# Access Compliance Report

## Public Rights-of-Way

### (Curb Ramps)

Intersection ID: 50580	Main Street: LONGSTRAW_RD	Cross Street: PAPER_TREE_RD	Location: NE
ADA ID: 4C105A1A3624	Ramp Type: Perp	Initial Pass/Fail: Fail	Overall Compliance: No
Severity Score: 13.75			
Codes/Mitigation Info/Possible Solution		Field Measurements/Component Compliance

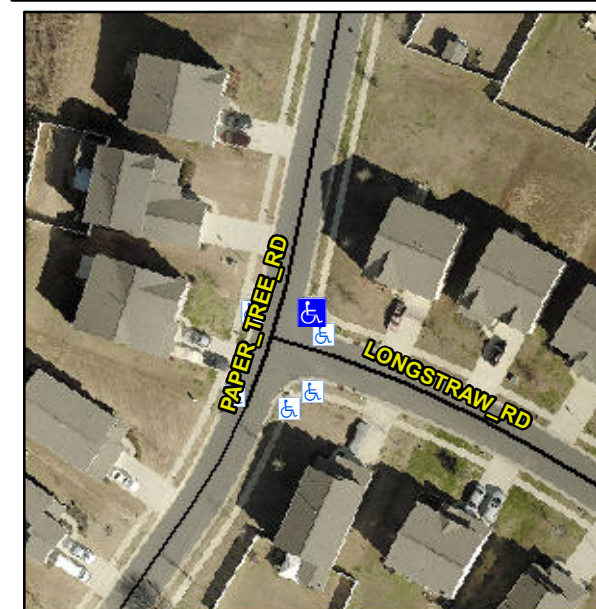
**Not Found, R304.2.2, R304.5.3**

Compliance	Description	Data	Compliance	Description	Data
N/A	Ramp Length (in)	48.0	No	Ramp Slope (%)	11.6
Yes	Ramp Width (in)	48.0	No	Ramp XSlope (%)	4.1
N/A	Flare Type LT	N/A	N/A	Flare Type RT	N/A
N/A	Flare Slope LT (%)	N/A	N/A	Flare Slope RT (%)	N/A
N/A	Flare Traversable LT?	N/A	N/A	Flare Traversable RT?	N/A
N/A	Landing Length (in)	N/A	N/A	DWS Provided?	N/A
N/A	Landing Width (in)	N/A	N/A	DWS Contrast?	N/A
N/A	Landing Slope (%)	N/A	N/A	DWS Length (in)	N/A
N/A	Landing X Slope (%)	N/A	N/A	DWS Full Width?	N/A
N/A	Landing Curb? (Y/N)	N/A	N/A	DWS Offset (in)	N/A
N/A	Shared Landing?	N/A			
N/A	Gutter Ponding?	N/A	N/A	Gutter Slope (%)	N/A
N/A	Gutter Lip Ht (in)	N/A	N/A	Gutter X Slope (%)	N/A
N/A	Painted X Walk1?	No	N/A	Painted X Walk2?	N/A
	X Walk 1 Direction	To W		X Walk 2 Direction	N/A
N/A	X Walk 1 Width (in)	N/A	N/A	X Walk 2 Width (in)	N/A
	X Walk 1 Slope (%)	0.5		X Walk 2 Slope (%)	N/A
	X Walk 1 X Slope (%)	2.0		X Walk 2 X Slope (%)	N/A

**Remove & Replace Entire Ramp.**
